**Addendum No. 2
February 16, 2023**

Project: Harrisburg Elementary School #8
Harrisburg, South Dakota
Architecture Incorporated Project #3000

Architect: Architecture Incorporated

4.34

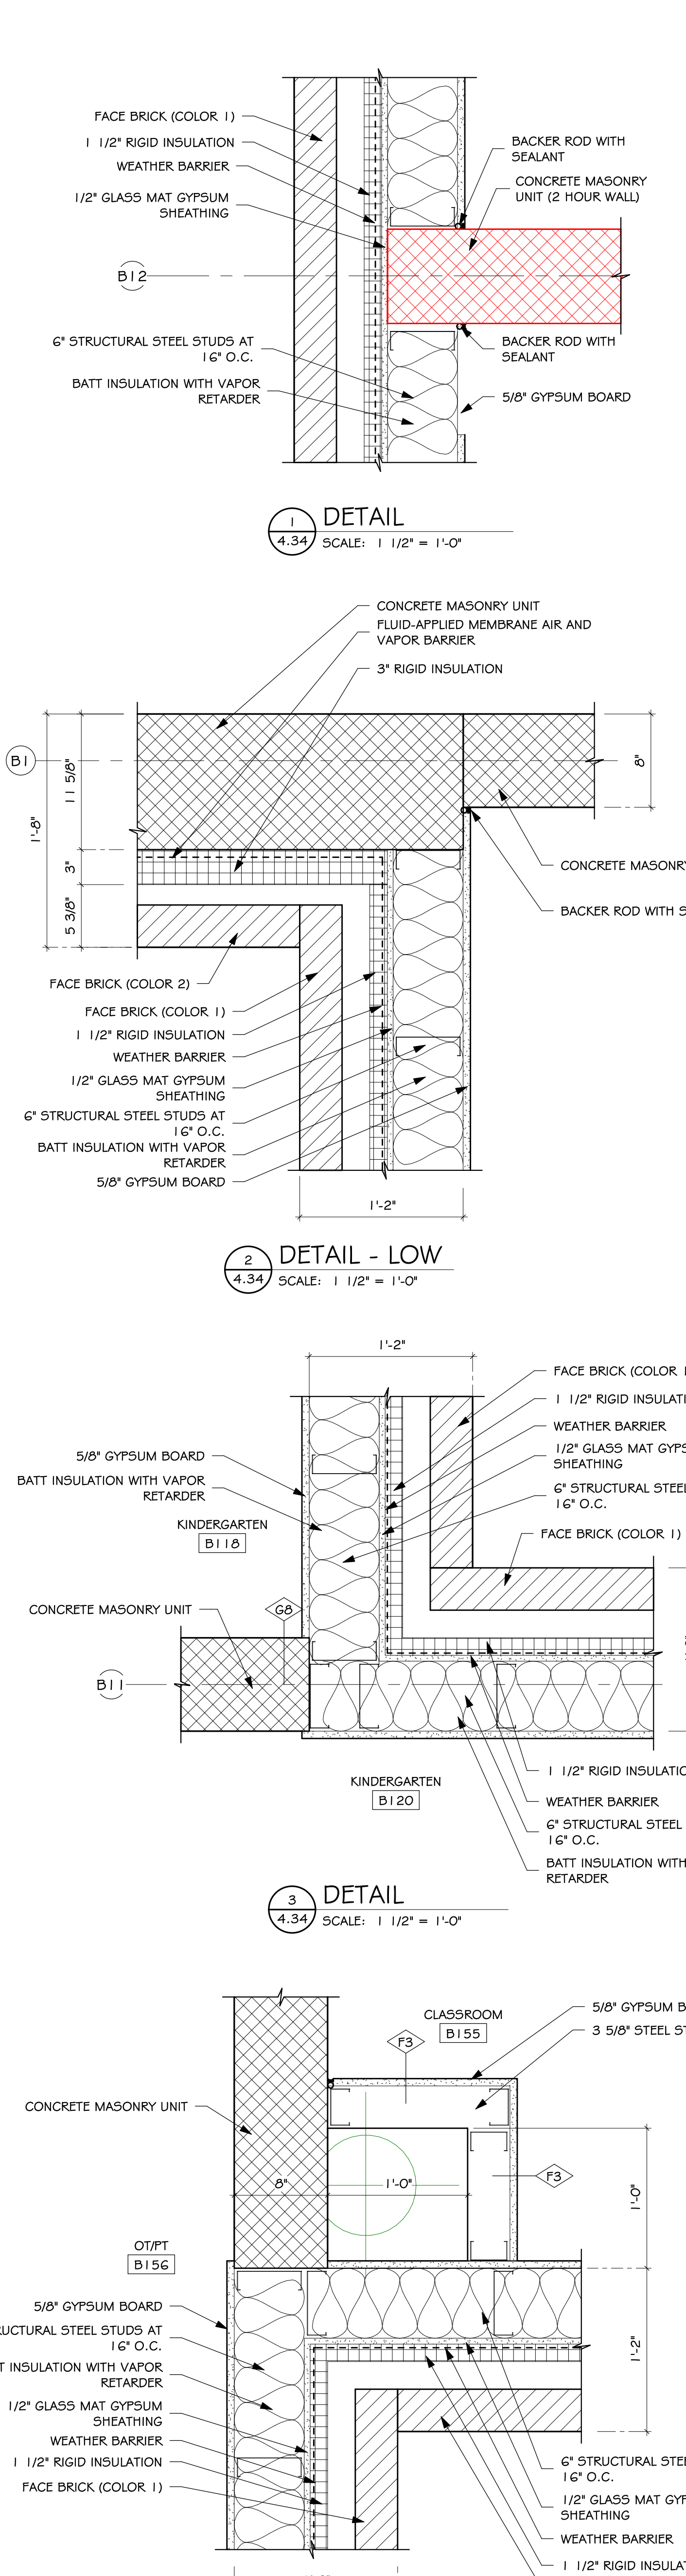
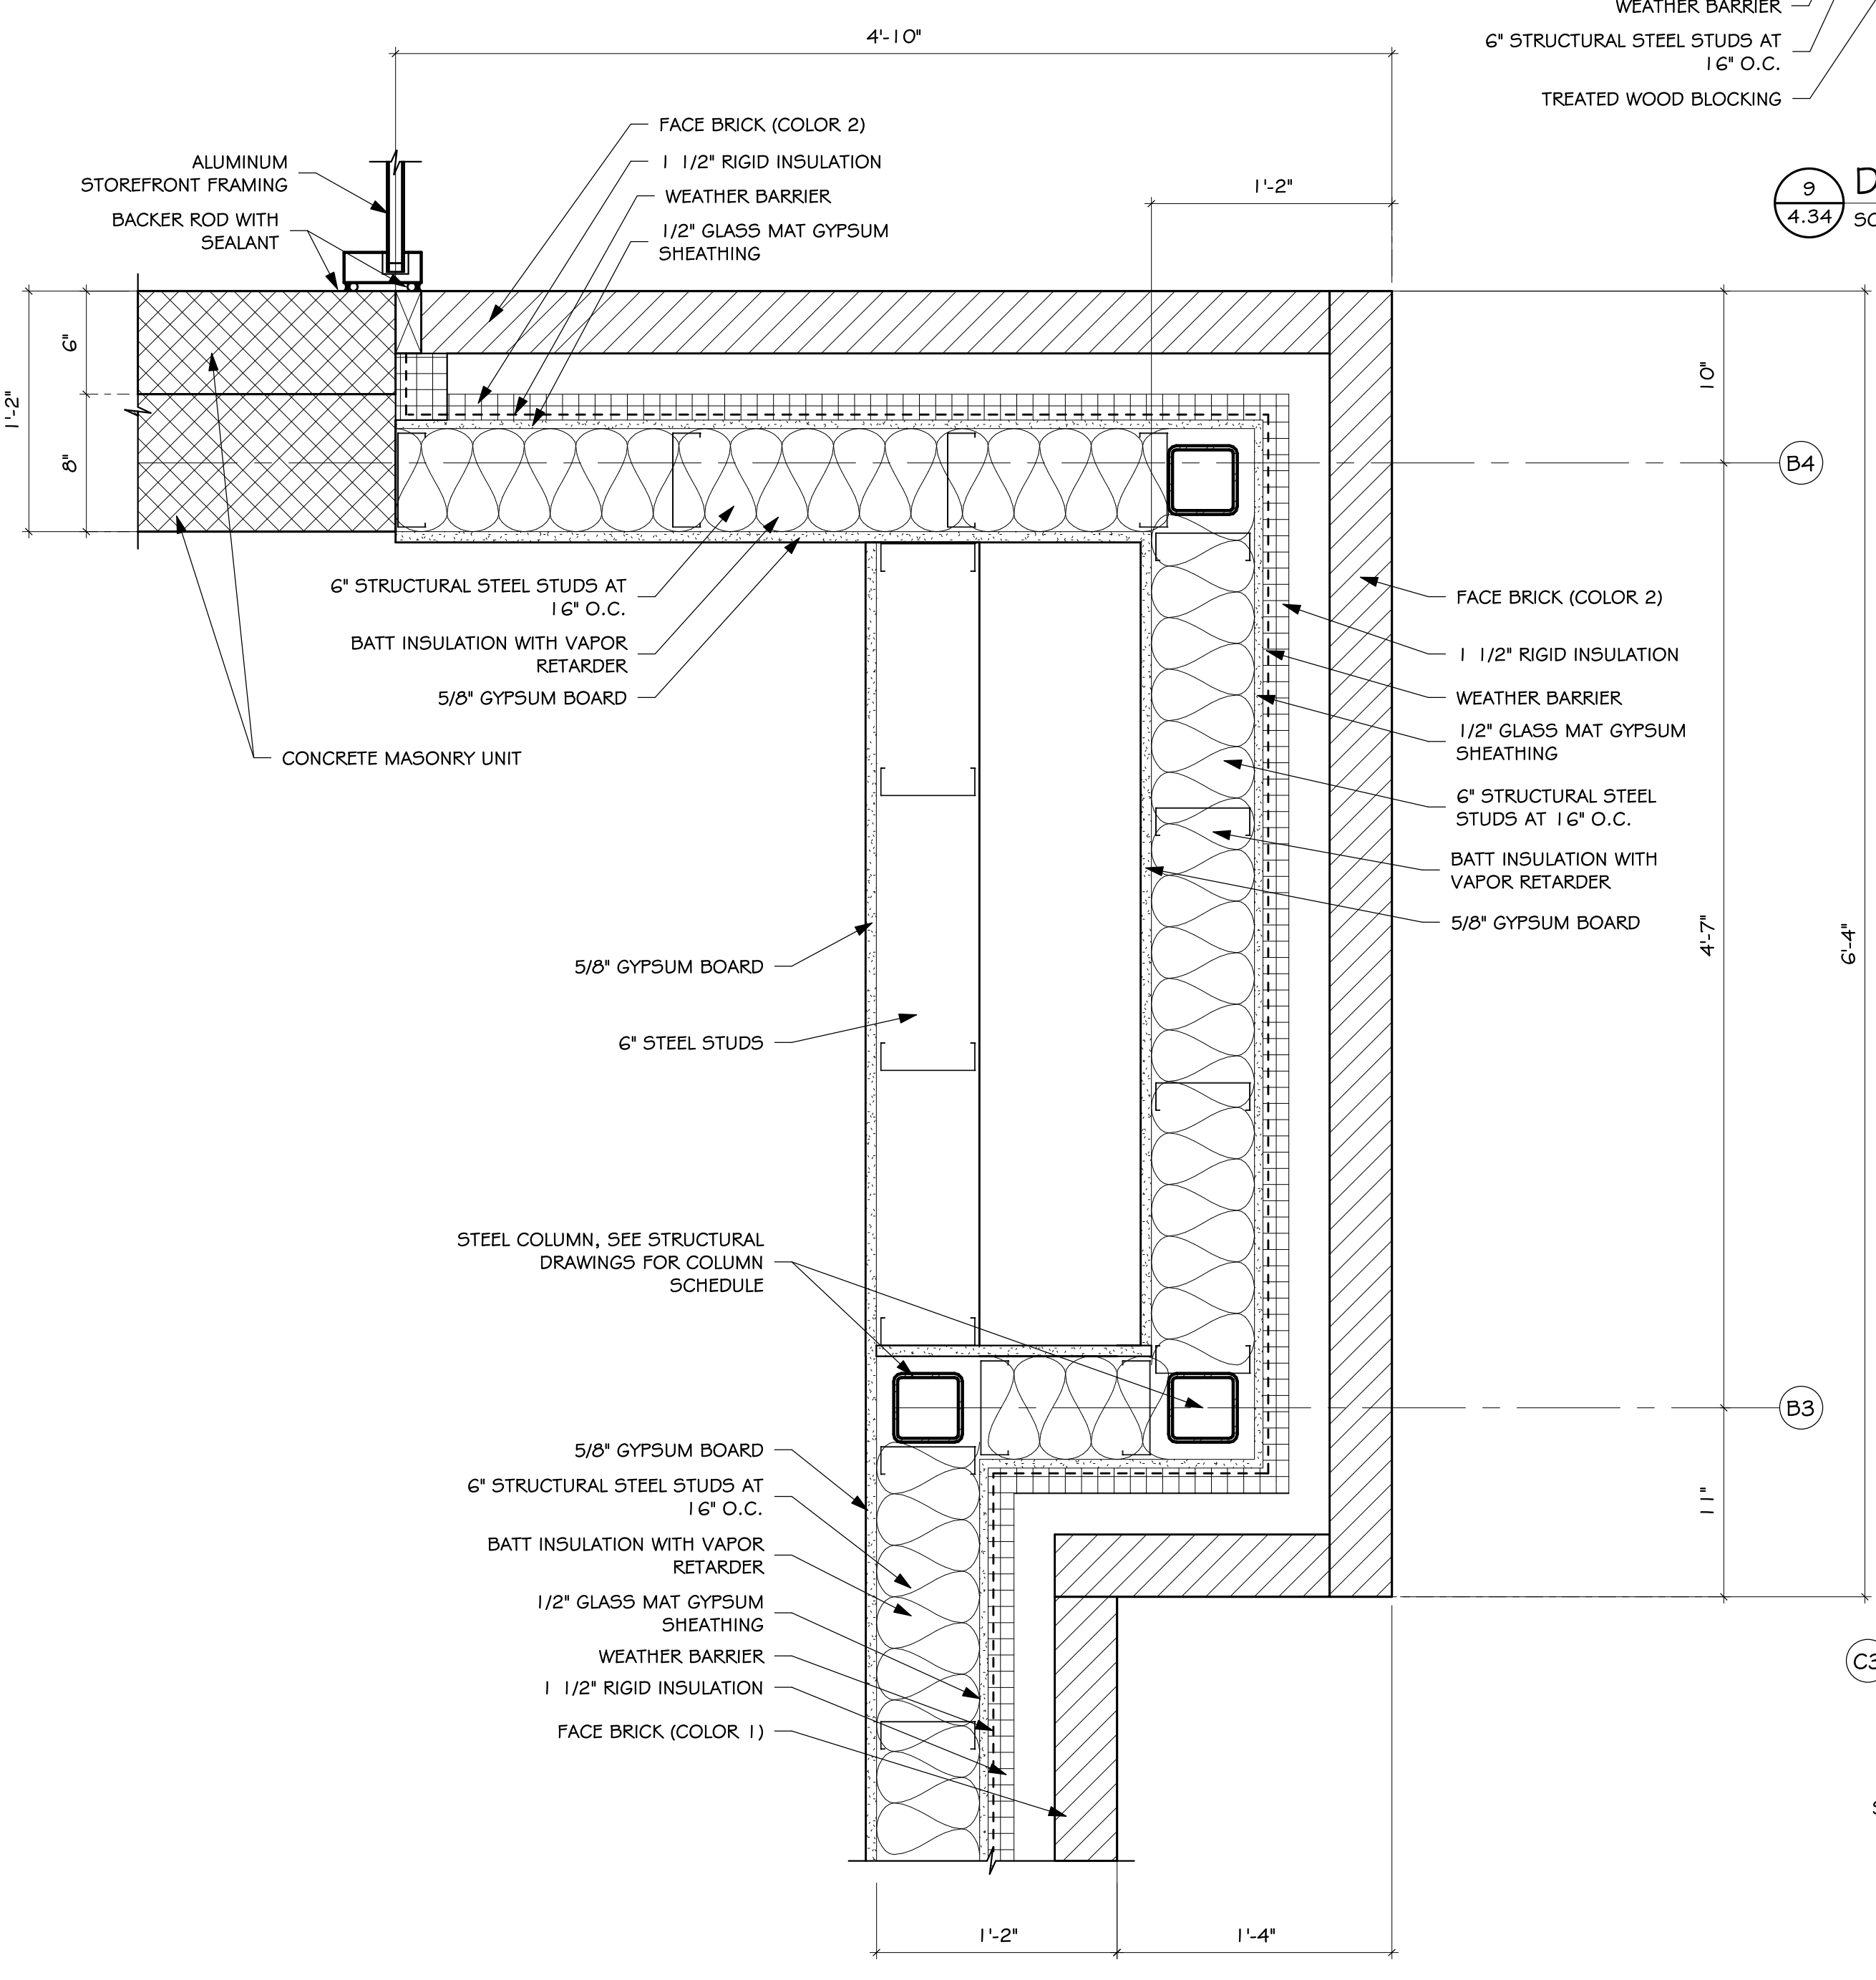
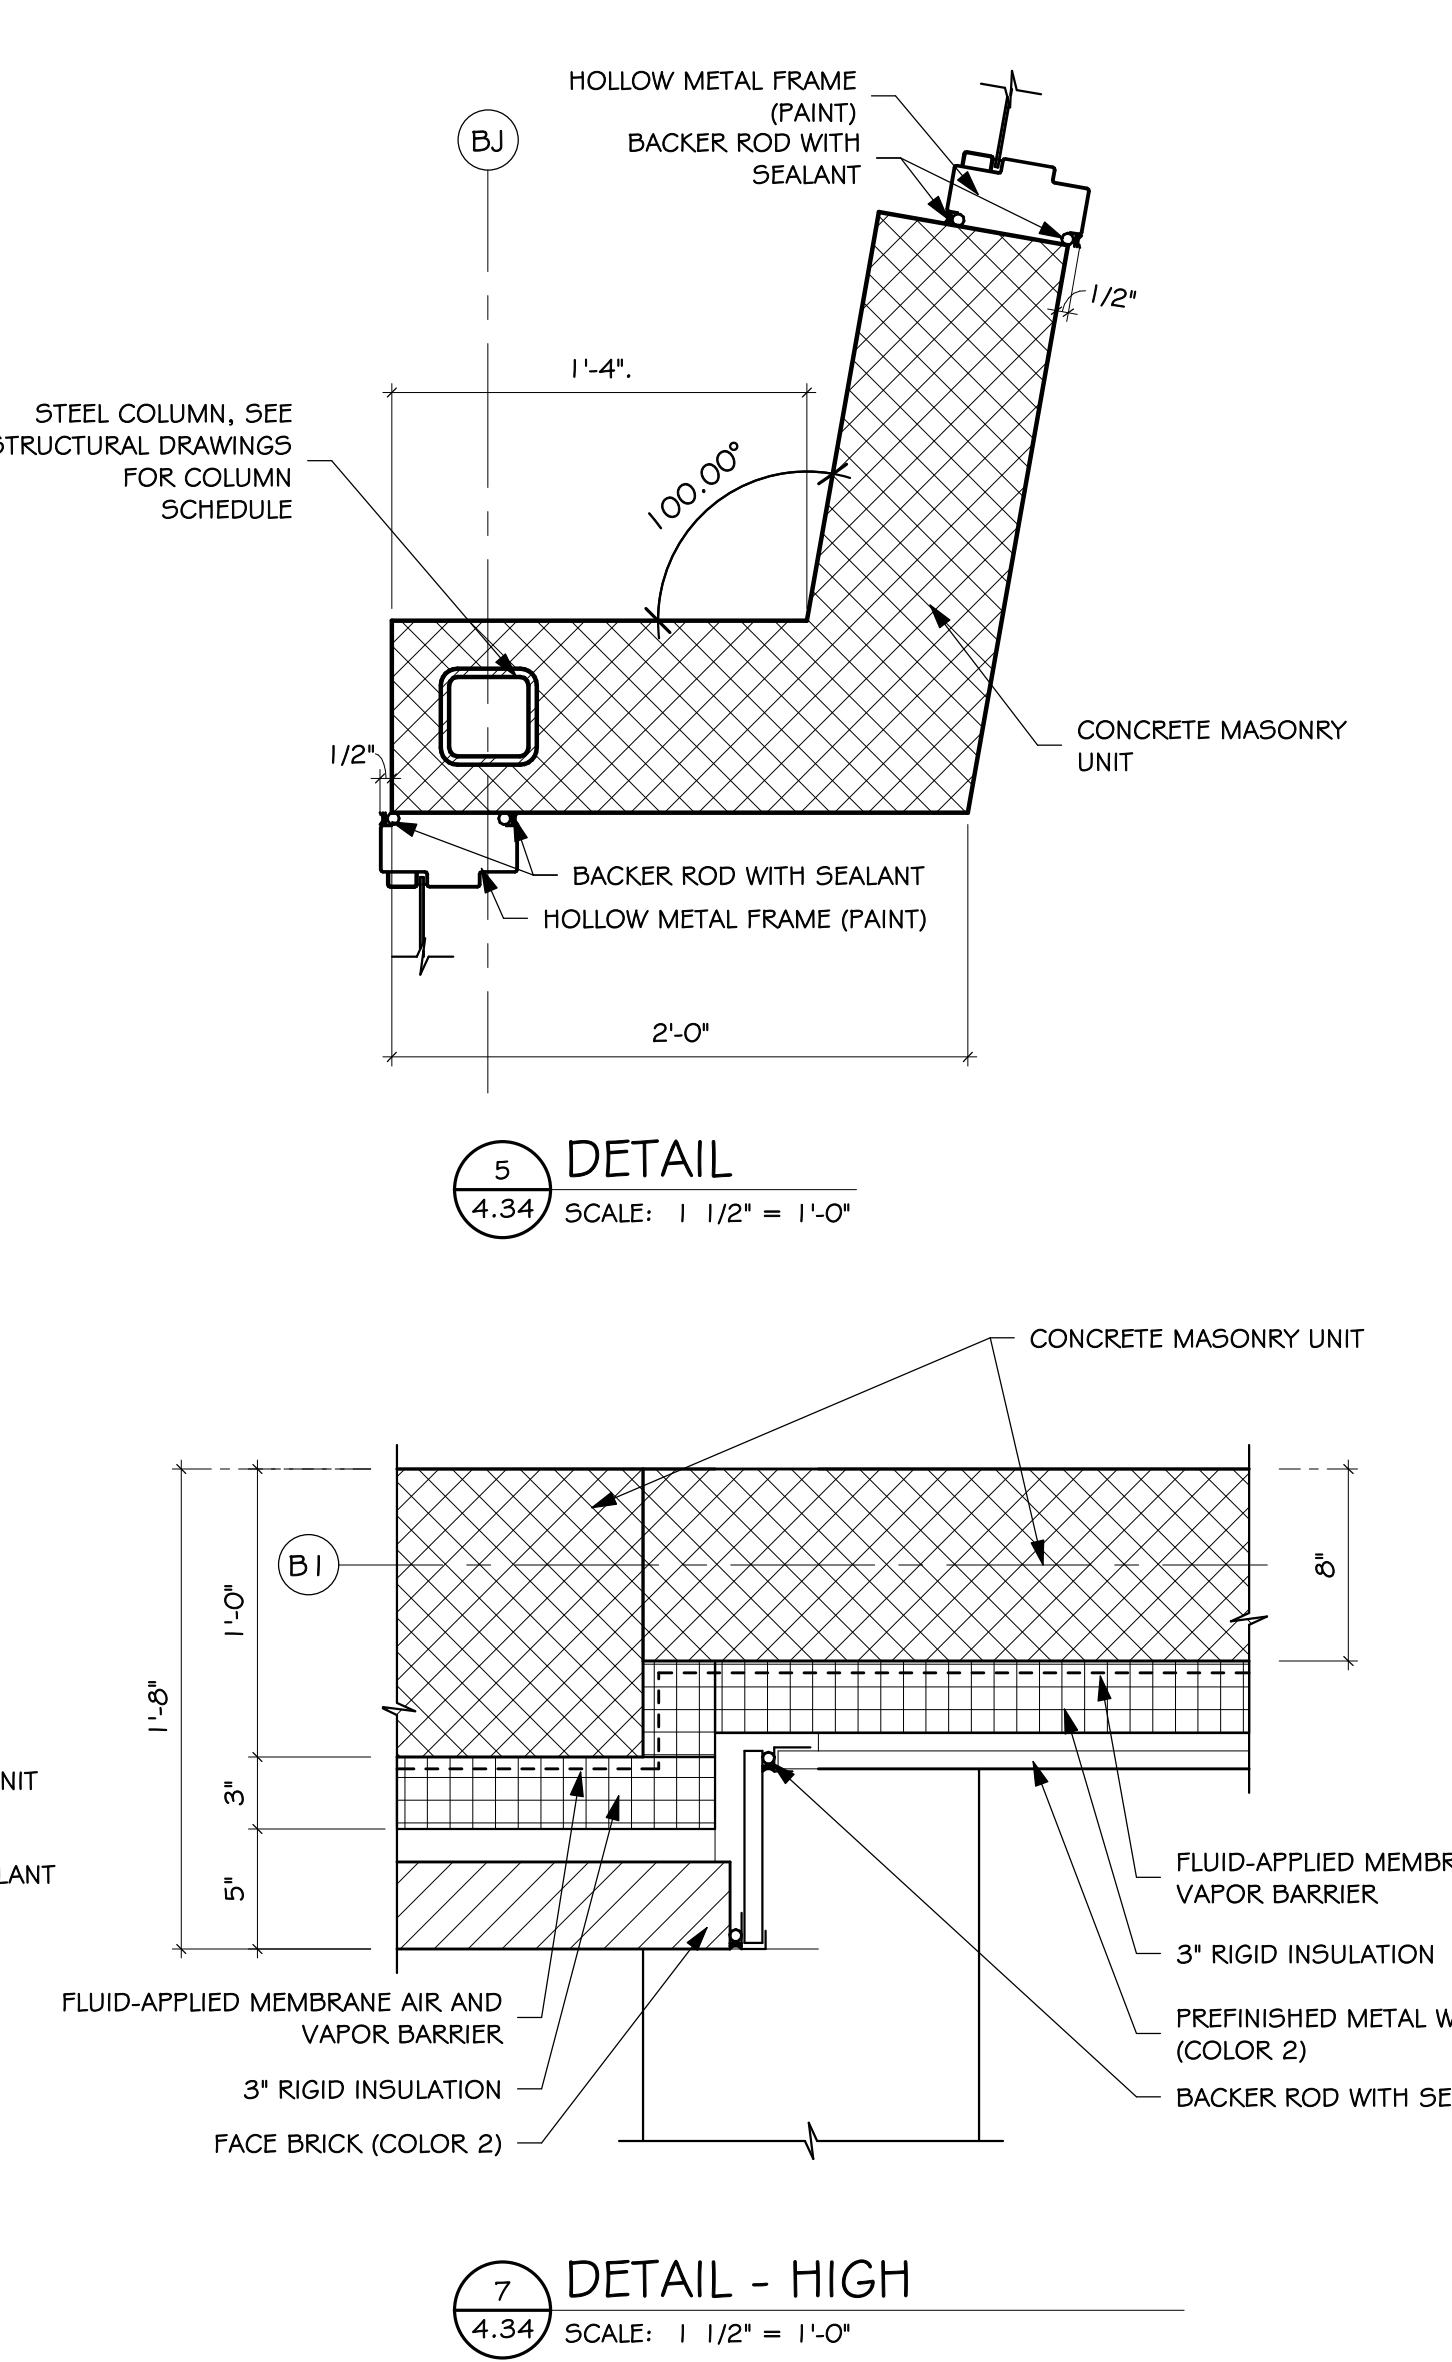
- a) Revise aluminum window jamb detail 11/4.34 as indicated per *revised* drawing Sheet 4.34, dated 2-16-23; see revised drawing Sheet 4.34 attached to the end of this addendum for additional information.
- b) Revise (Type F) storm shelter window jamb detail 13/4.34 as indicated per *revised* drawing Sheet 4.34, dated 2-16-23; see revised drawing Sheet 4.34 attached to the end of this addendum for additional information.
